ADDENDUM NO. 1

Invitation to Bid (ITB) No. 21-101447, 2021 LMIG Road Resurfacing Projects (365 Day Contract) is hereby modified as follows:

DS-1

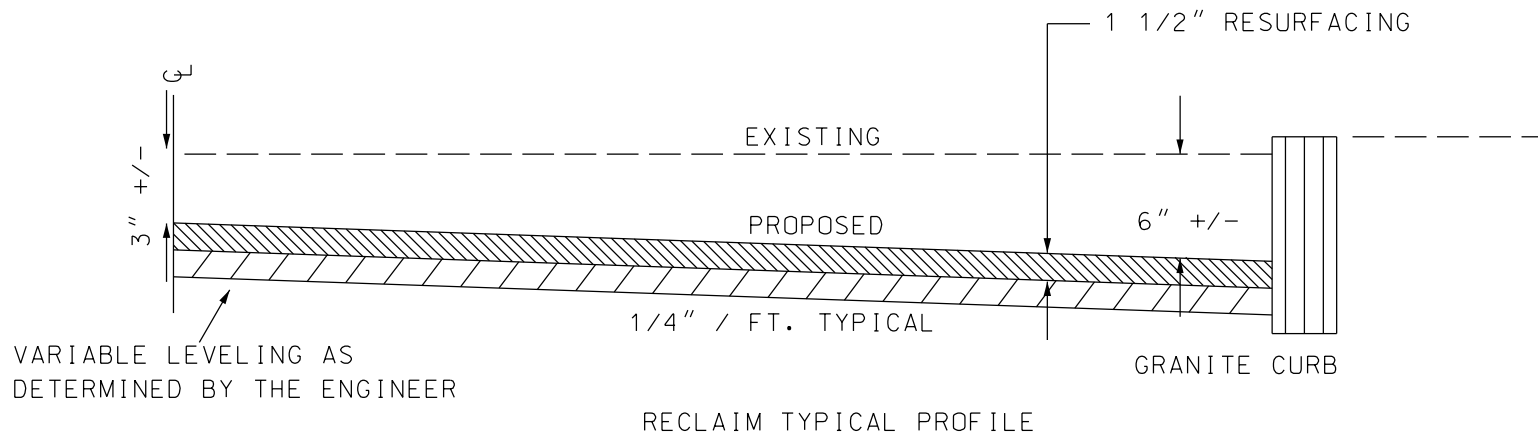
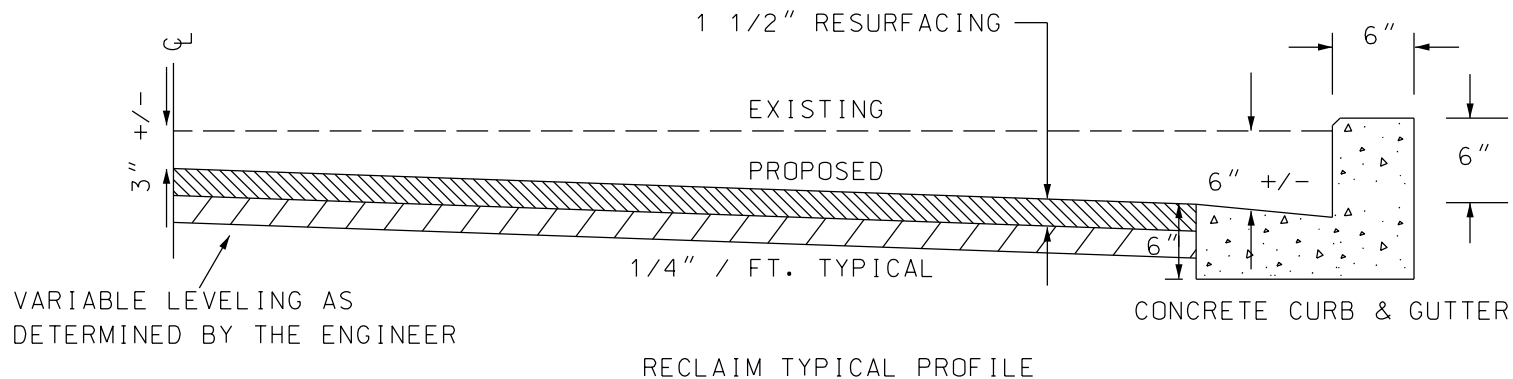
- o. Question: What is going to be the Required Depth for the Milling?

v. Question: Within Exhibit II, page 116 of 118 Paragraph VIII refers to Patching, Milling, Resurfacing and Technical Drawings Specifications. We did not find the Typical Section Drawings (DS-1, DS-2, DS-3, DS-4) that are referenced in this paragraph, can you please provide them?

Answer: Milling depth varies and shall be determined by the Project Manager and or Construction Inspector.

Answer: The Drawings are included in the Addendum.

DS-2

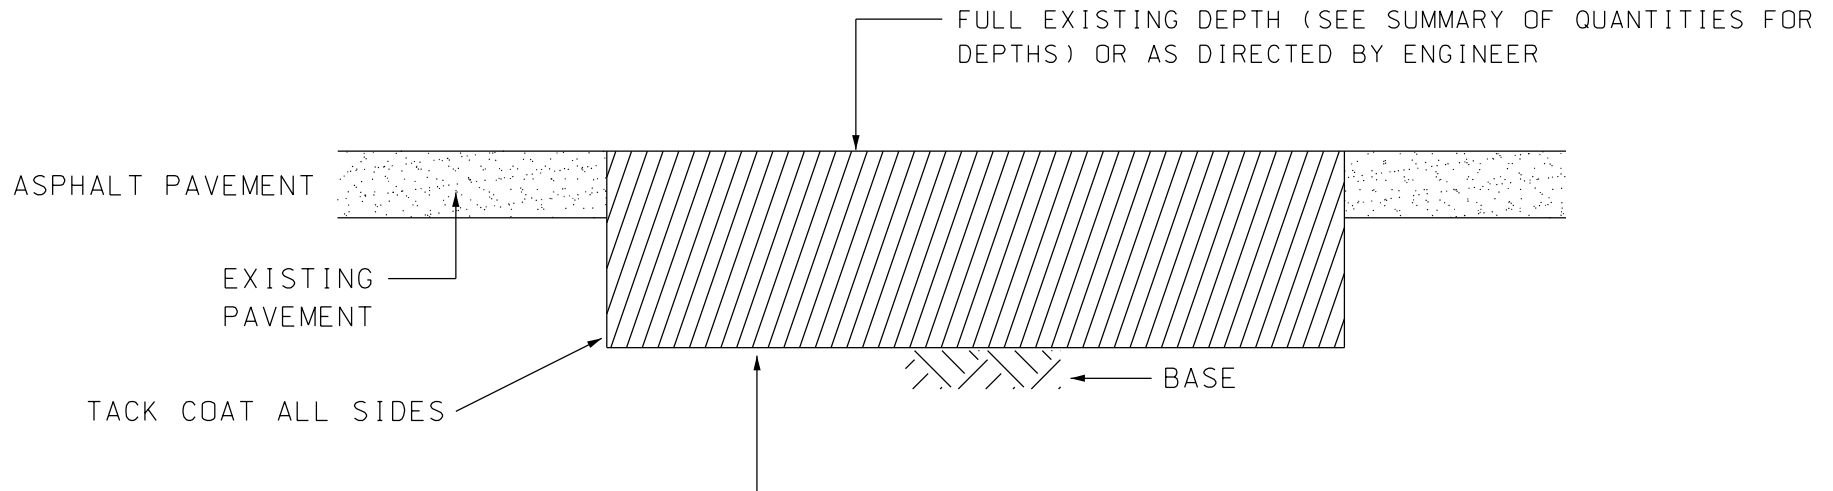
Answer: Yes, an overlay of 1.5 inches shall be added. It will not be required to remove an additional 1.5 inches before patching or resurfacing.
 - b. Question: Can you please provide the average expected depth for the patching?

- t. Question: Within Exhibit II, page 109 of 118 Paragraph K refers to paving back the patching areas. It says that 9.5mm or 19.0mm shall be used. There is a tremendous price difference between these two mixes and structurally the 9.5mm will make a poor quality patching mix. Would you please identify the roads that you anticipated will get patched with 9.5mm so we can properly price out the Patching bid item? Keep in mind that 9.5mm Patching is very likely to fail in a much shorter time frame.

Answer: There is no average depth, but the minimum depth shall be no less than 2 inches.
 - c. Question: Will 19mm be the only mix type used for filling in the patches?

Answer: All roads shall be patched with 19MM.

DS-3

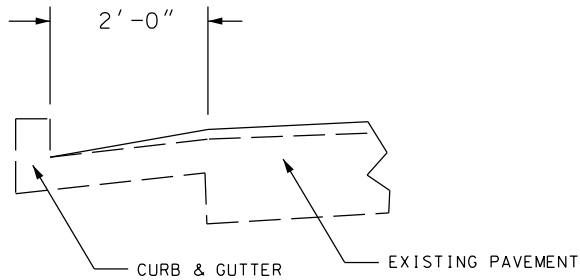
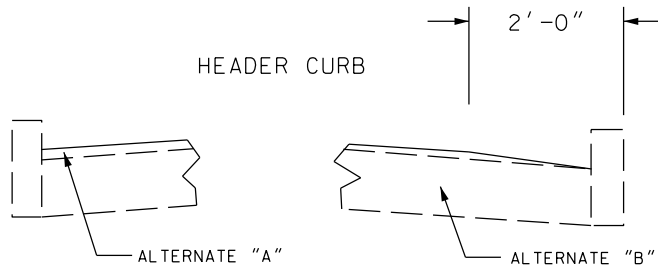
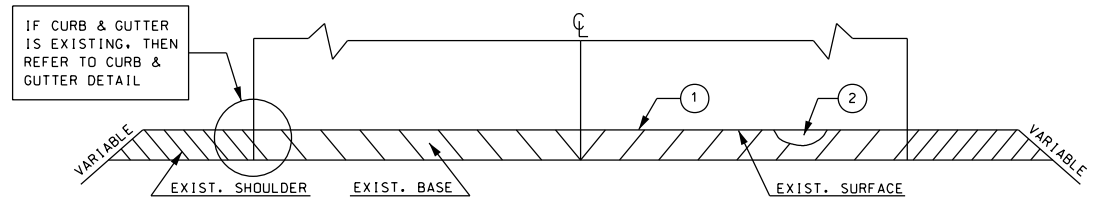
u. Question: What will be the paving depth for each road for the final surface 9.5mm Type II paving?

Answer: 1.5 inches.

DS-4

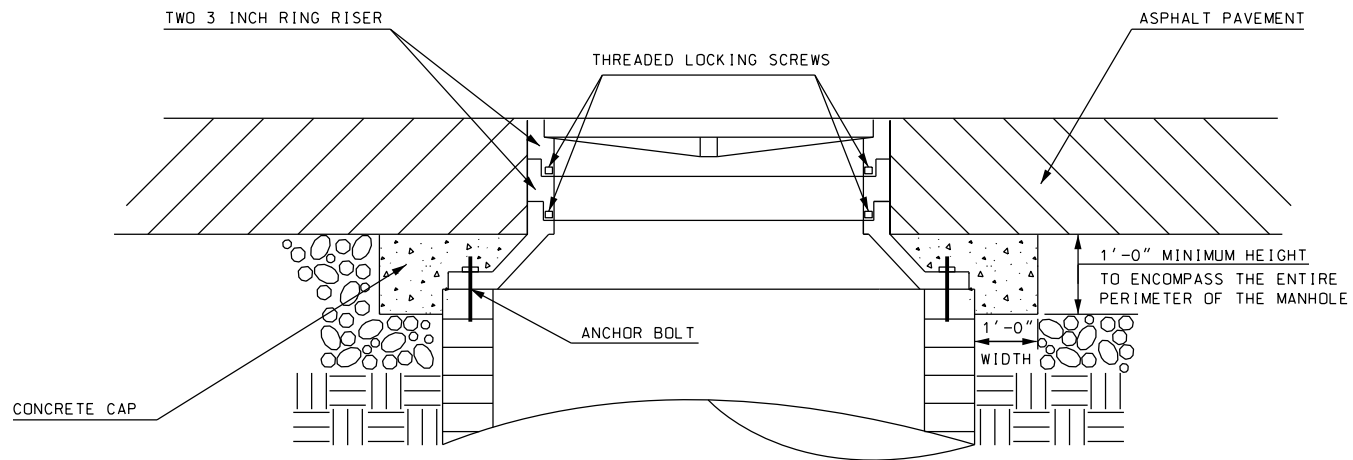
Answer: Yes.
 - d. Question: Just for clarification, the drop inlets and drains are to be adjusted by the contractor, but if any manholes are to be raised after paving, will the county handle that or will the contractor be responsible for those as well under Item No. E (611-8055)?

Answer: The County shall be responsible for the adjustment and/or raising of sewer manholes lids.
 - e. Question: Item No. C (423-5010) Variable Depth Mill quantity is only 25,000 square yards. Can the county please explain where this milling will be required?
